Commonwealth Edison  
1400 Opus Place  
Downers Grove, Illinois 60515

Subject: LaSalle County Station Units 1 and 2  
Failure of 2CM025A Valve  
NRC Docket Nos. 50-373 and 50-374

Reference: (a) B.L. Siegel letter to Commonwealth Edison Company, dated October 5, 1992; Summary of Meeting on Post-Accident Sampling System (PASS) Isolation Valves, August 27, 1992, and Follow-up Discussions with the Licensee, Received by Commonwealth Edison October 14, 1992.

FIGURE 1

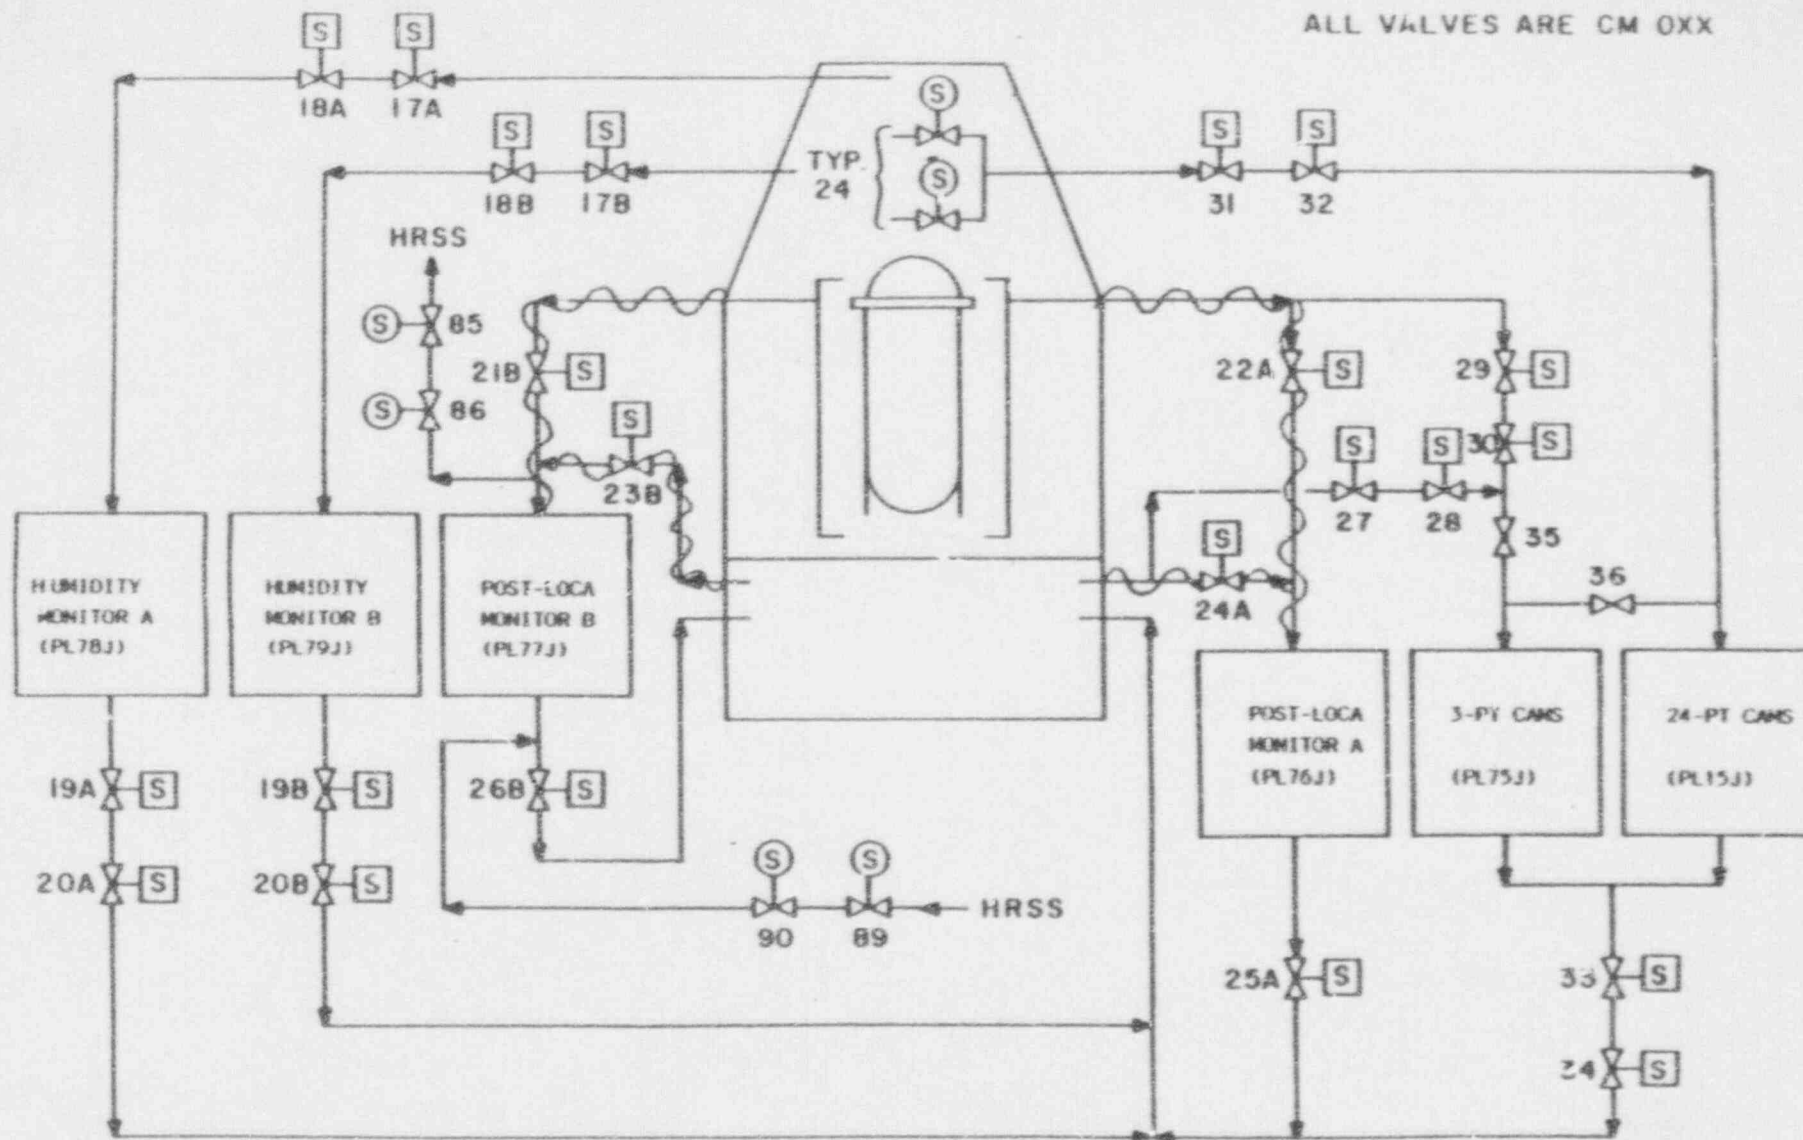
Valve 2CM025A is a normally closed solenoid operated valve, which energizes to close, and fails in the open position upon loss of electrical power. (See attached Figure 1.) There are two other similar valves for each Containment Monitoring skid. During accident conditions, Primary Containment Isolation System (PCIS) initiation logic operates the drywell supply valve (2CM022A) and suppression chamber return valve (2CM025A), and prevents manual operator actions from closing either valve until the PCIS signal is reset. Because these valves are required to remain open after a LOC, they are part of a system which constitutes a closed loop outside of the containment. Accordingly, they are left open for Type A testing, and are not presently subject to Type C test. (See UFSAR Table 6.2-21, Note 40.) These circumstances further reinforce the view that the ability to sample post-LOCA containment atmosphere was the primary concern and that containment integrity would be preserved through piping design and Type A testing.

- The three isolation valves per skid will be Appendix J Type C tested from the reverse direction (skid toward containment). Both the 1CM025A and 2CM025A valves are presently installed such that the valve inlet port is away from the containment, providing a non-conservative Type C test. The orientation of both 1CM025A and 2CM025A will be changed such that the inlet port is towards the containment. This re-orientation will be implemented on both Unit 1 and Unit 2 during the first outage requiring a Type A test after each Units fifth refuel outage.

- Contingent upon approval of the Technical Specification Amendment Request, the isolation logic for valves 1/2CM022A, 1/2CM025A, 1/2CM021B, and 1/2CM026B will be modified to remove the PCIS interlock from the logic circuit. After modification, these valves will operate in an identical fashion to 1/2CM024A and 1/2CM023B in that their only method of operation will be remote manual operation from a control switch in the Main Control Room. The design change will be implemented on Unit 2 prior to the startup from the Unit 2 fifth refuel outage, L2R05, tentatively scheduled to begin in the Fall of 1993, and on Unit 1 prior to the startup from the Unit 1 sixth refuel outage, L1R06, tentatively scheduled to begin in the Spring of 1994.

- The valves will continue to fail open upon loss of power.
- The three isolation valves per skid will be in the open position for the Appendix J Type A test to test the piping integrity.
